DEXIN Corporation, Ltd

Model: K3C

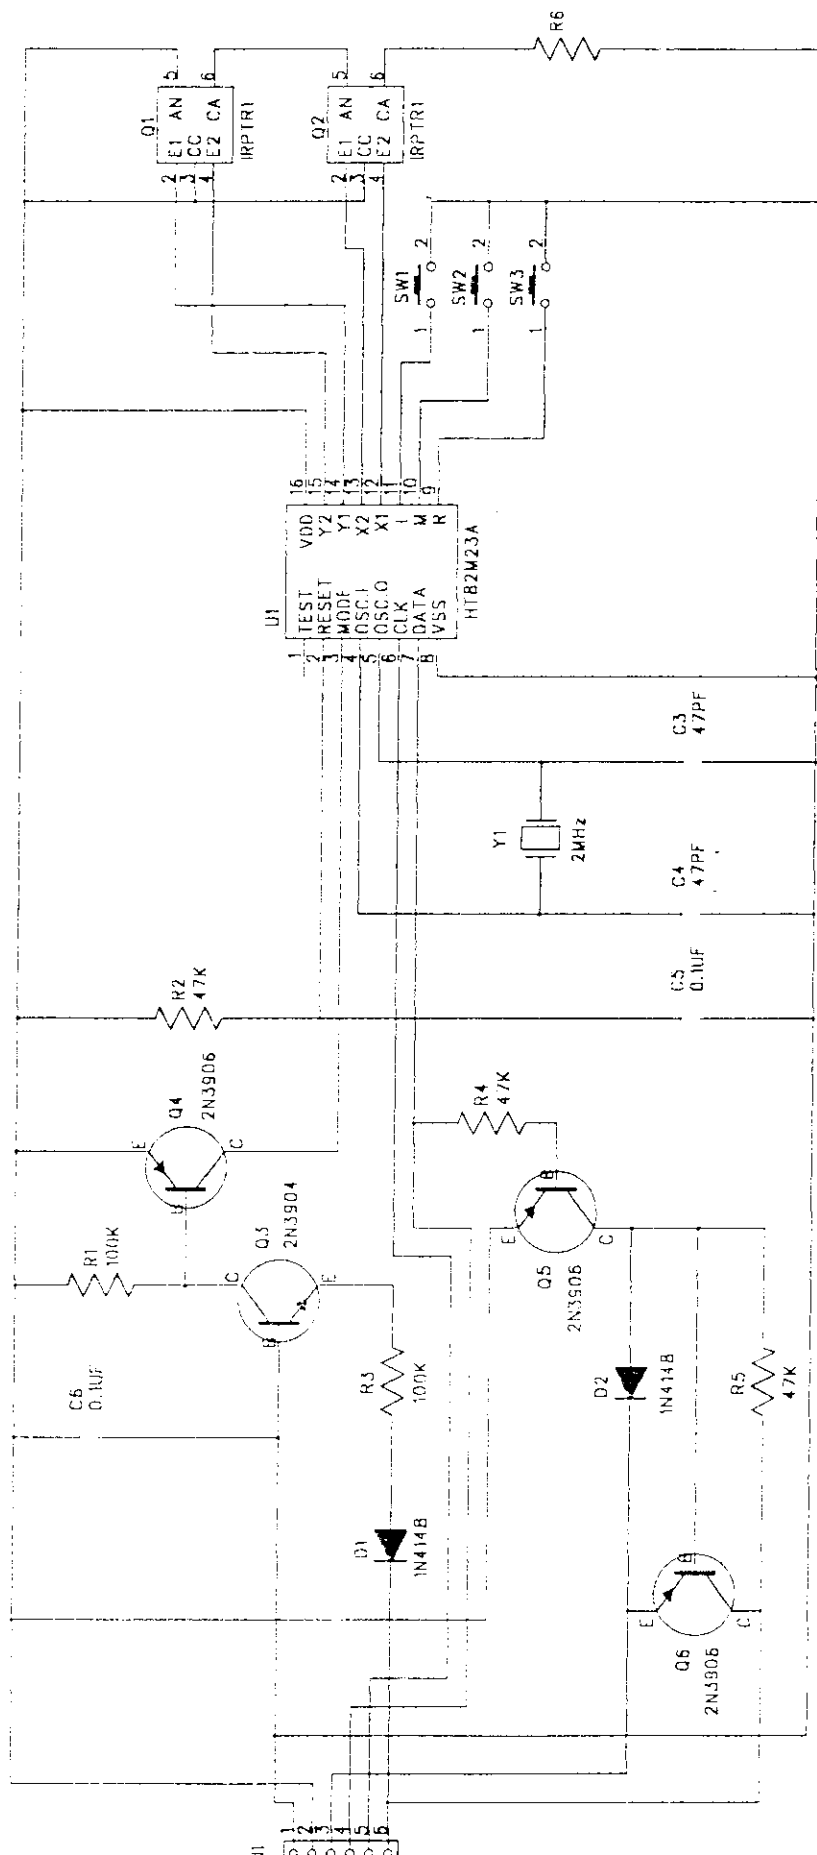
Note:
 For backward compatibility to the prior FCC and CE passed PCB,
 R2 is retained but will not be installed.
 R1 is retained for the same reason as R2 is.
 R1 has been replaced by D2.
 ***The previous controller for serial mouse was HT6515,
 but is switched to HM8375, or HM8370 (next alternative).
